Floyd Hill - Early Projects
ALIVE ITF Meeting
April 11, 2022, 2:00 PM to 4:00 PM
Virtual - Google Meet

I-70 Floyd Hill to Veterans Memorial Tunnels

Early Projects: Wildlife Crossings

ALIVE Meeting

MP 254.5 – Genesee: Fence Alignment

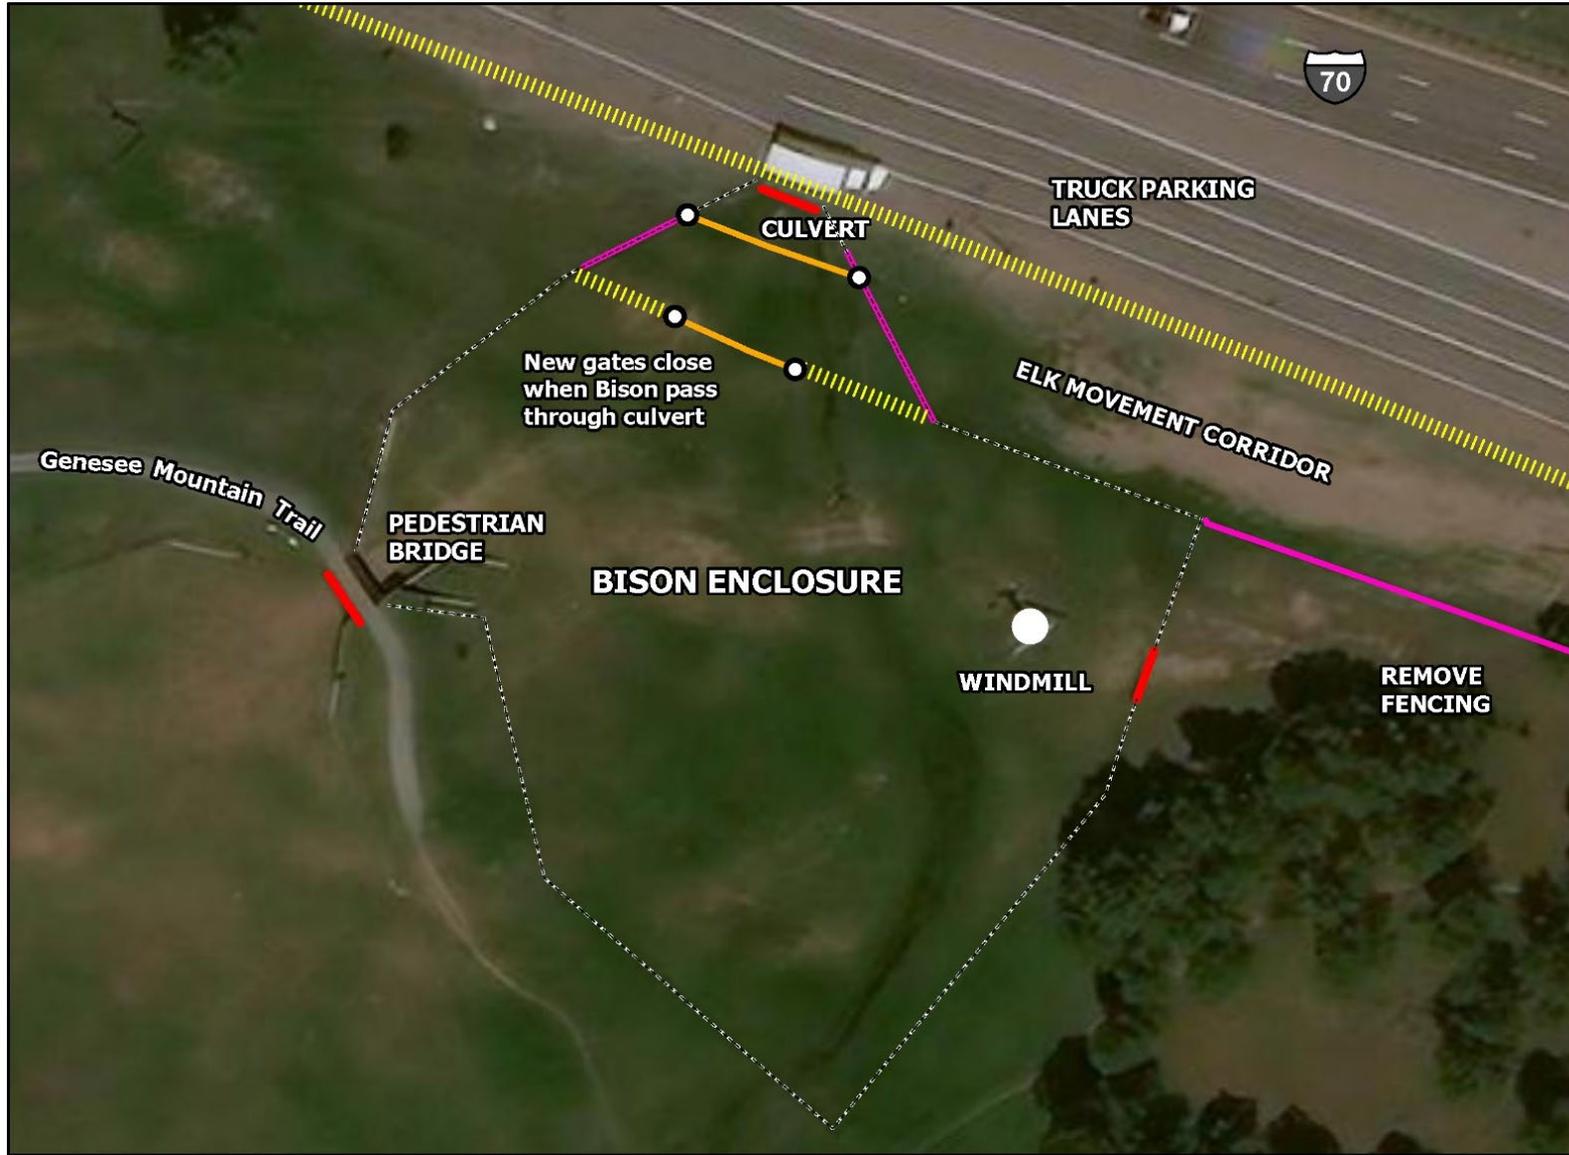
- *Comment:* Kevin Brown (CDOT) noted that there are no gates along the HOA fence but there are a few panels missing. CDOT might need to build their own fence. He also expressed concern about wildlife using the bridge overpass and potentially entering I-70 via the on-ramps.

Colorado Parks and Wildlife (CPW) and Denver Mountain Parks agreed that it should be left open for elk to cross. Tim Woodward (CPW) suggested that a "jump out" near the Katherine Craig Park and HOA fencing would be beneficial. Brad Eckert (Denver Mountain Parks) noted that fencing on the bridge itself would have visual impacts.

Response: Julia noted that elk currently cross over the bridge structure, typically at night. This has been discussed in prior meetings and it was generally agreed that the overpass should continue to allow elk to move across. Given the low traffic volumes and the fact that they do not currently enter the on ramp, it is currently the preferred solution. Julia noted that this is something that needs to be re-visited by the group and posed two questions: (1) Do we agree to keep the bridge open? and, (2) If so, are we comfortable not having some level of mitigation control on the on/off ramps?

Julia agreed to go look at the area again, especially the southwest quadrant of the Genesee interchange to get a feel for whether additional guards might be effective. Although adding guards could increase the cost of the project, it would be more difficult to make any adjustments once the project is complete.

US 40, MP 257.4 – Empire: Wildlife Overpass

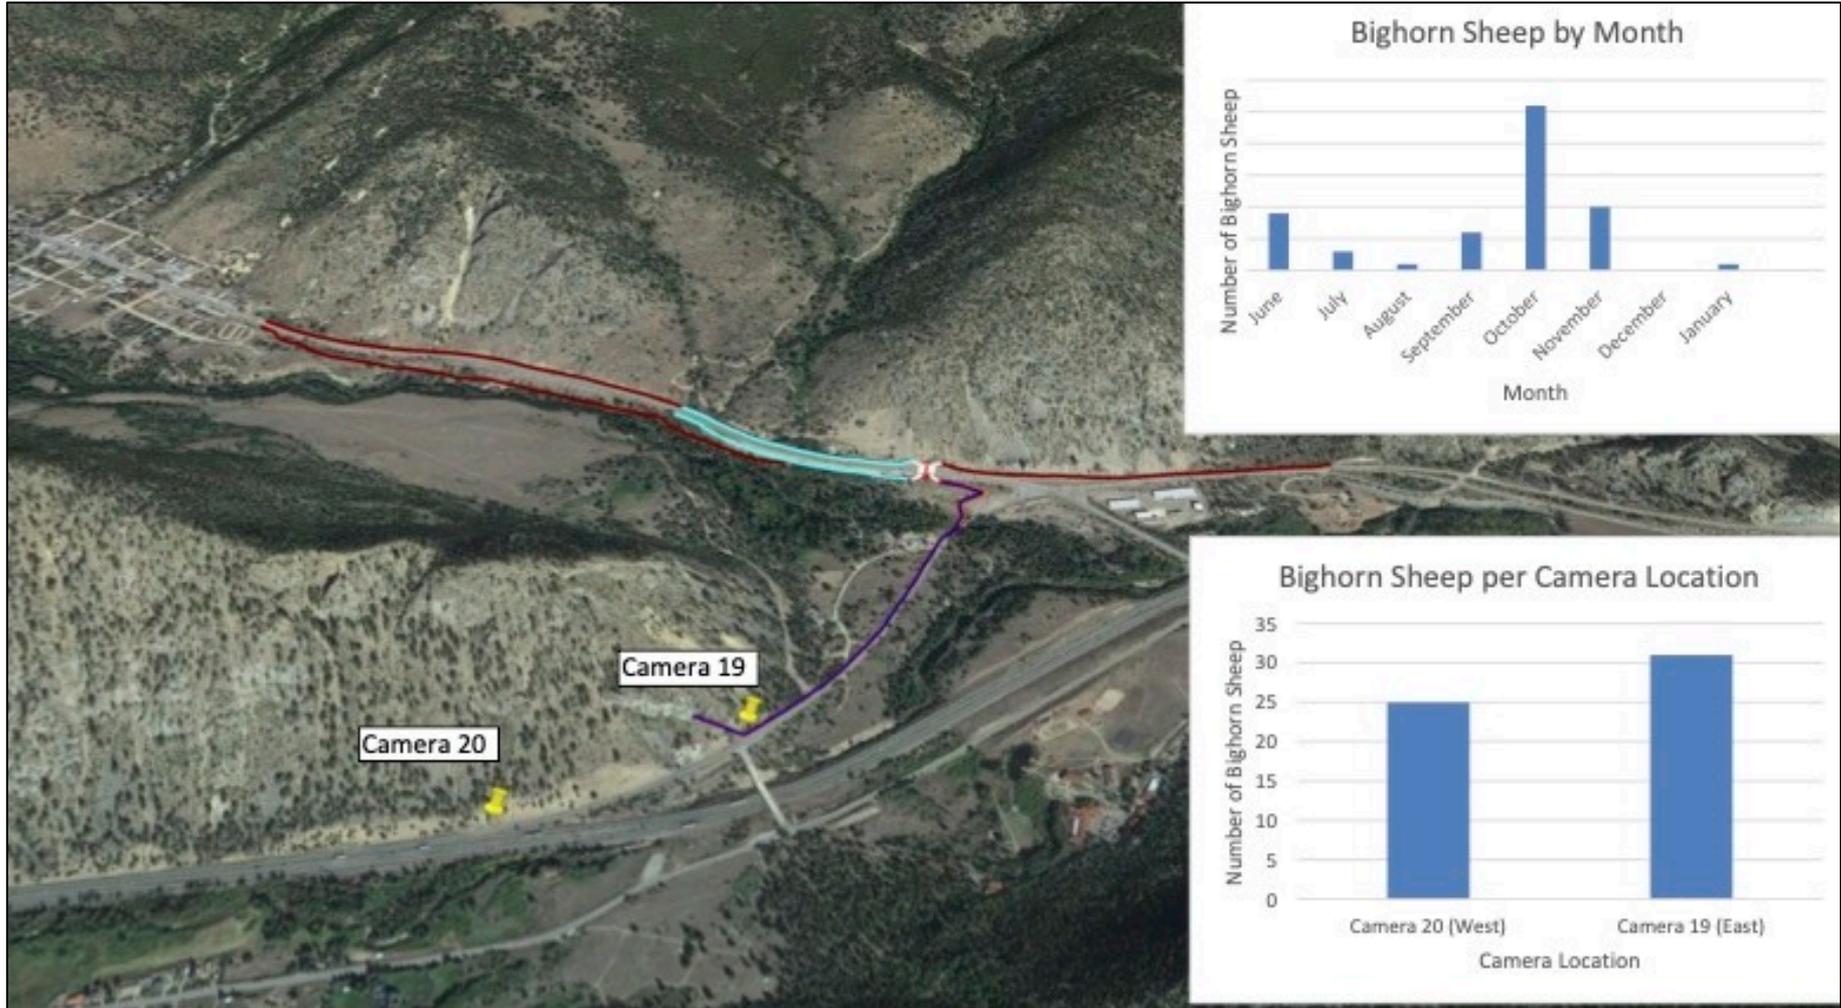
- *Comment:* The Town of Empire, Clear Creek County and FHWA expressed concerns about the aesthetics of the structure since it will be visible in the entrance to Empire. They asked if the design would follow the I-70 Mountain Corridor aesthetic guidelines.

- *Question:* Julia asked if creating game trails along the slopes on the north side of the overpass would facilitate access for deer and elk, given the steep terrain (which is not an issue for bighorn sheep).

- *Response:* The design will follow the I-70 Mountain Corridor aesthetic guidelines, though the guidelines are not specific about wildlife crossing structures, which have different requirements than roadway bridges. It was acknowledged that both the structure and retaining walls will change the visual character of the area. Stephanie Gibson noted that Region 3 utilized shotcrete walls for their runaway truck ramp on Vail Pass that looked very natural and aesthetically pleasing. Kevin Brown agreed to provide more information on this approach.

- *Answer:* Joseph Walter (CPW) noted that deer and elk would certainly use a trail if it were there.
